Docket No. 50-423  
B13627

Attachment 2  
Millstone Nuclear Power Station, Unit No. 3  
Proposed Technical Specification Changes  
Cycle 4

November 1990

Millstone Nuclear Power Station, Unit No. 3  
Proposed Technical Specification Changes, Cycle 4

FIGURE 2.1-1  
REACTOR CORE SAFETY LIMIT - FOUR LOOPS IN OPERATION

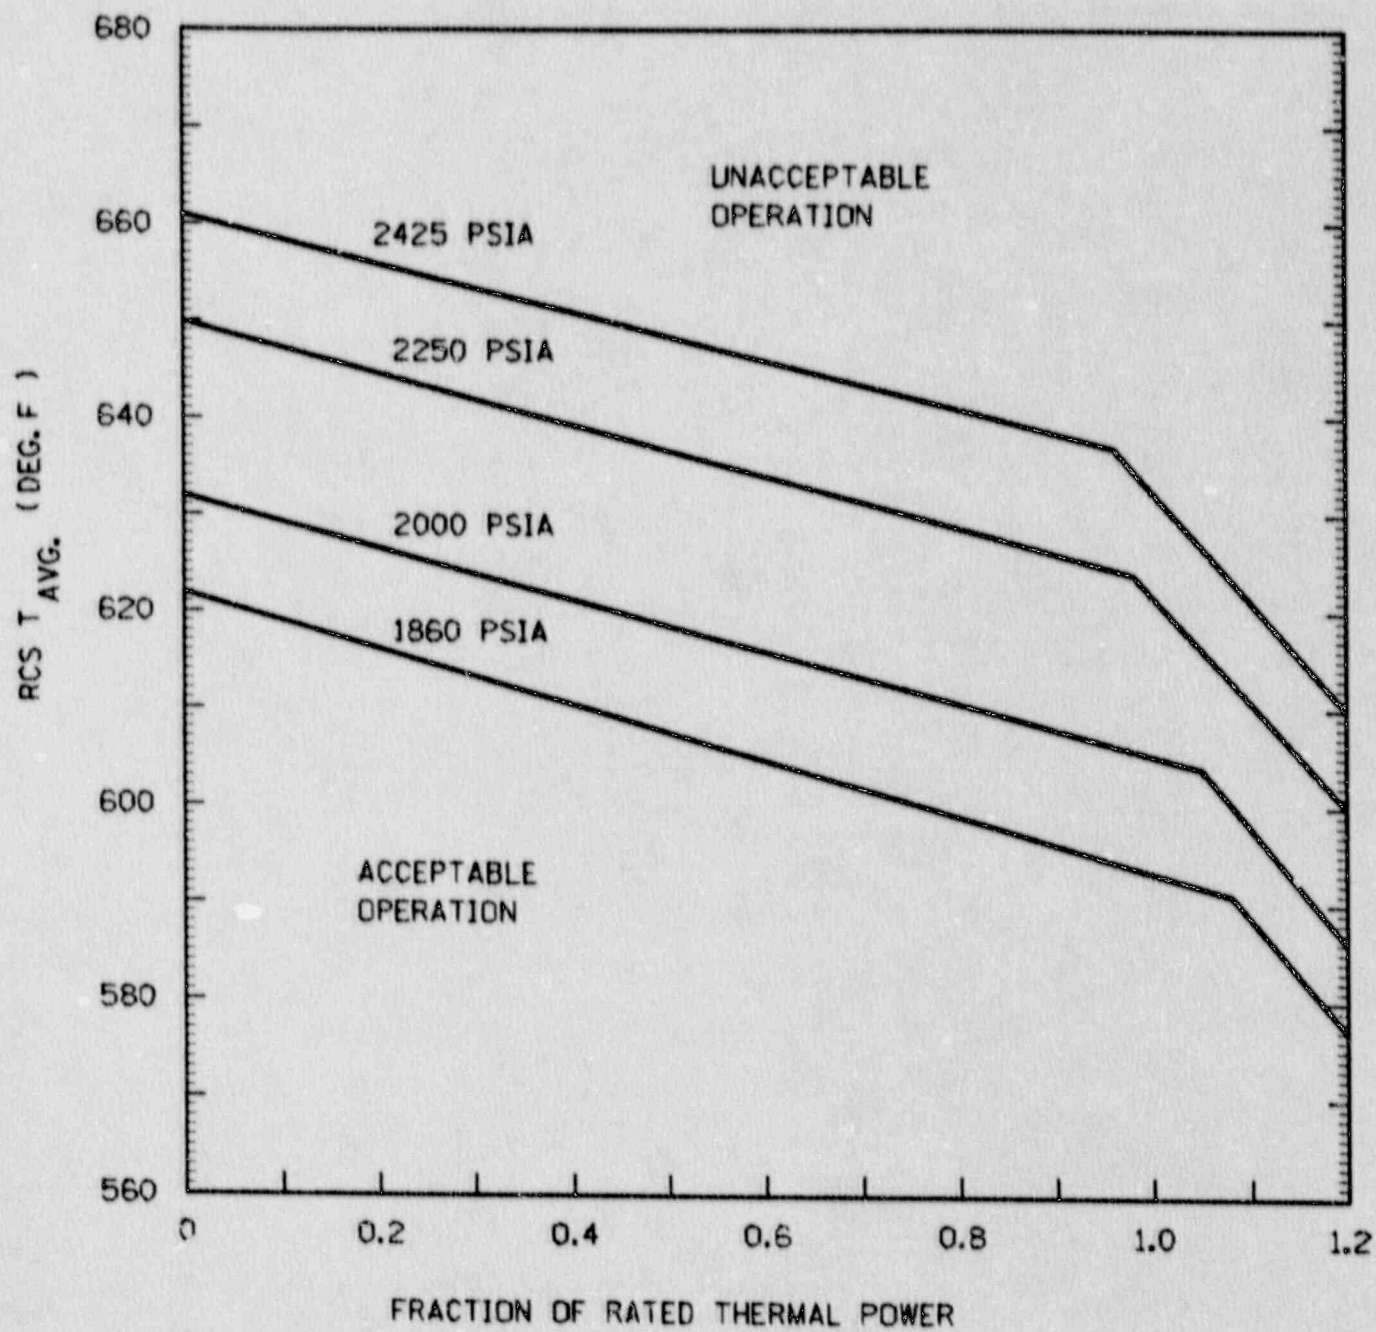
The curves of Figures 2.1-1 and 2.1-2 show the loci of points of THERMAL POWER, Reactor Coolant System pressure, and average temperature below which the calculated DNBR is no less than the design DNBR value or the average enthalpy at the vessel exit is less than the enthalpy of saturated liquid.
